Red highlights reflect deviations from the released schematic that required rework. 20210414

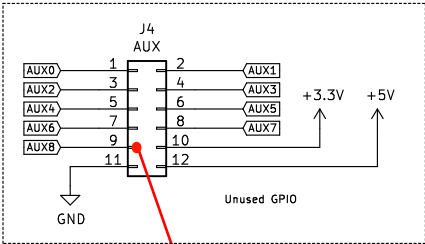
CAN \*INT  
MOVED  
HERE
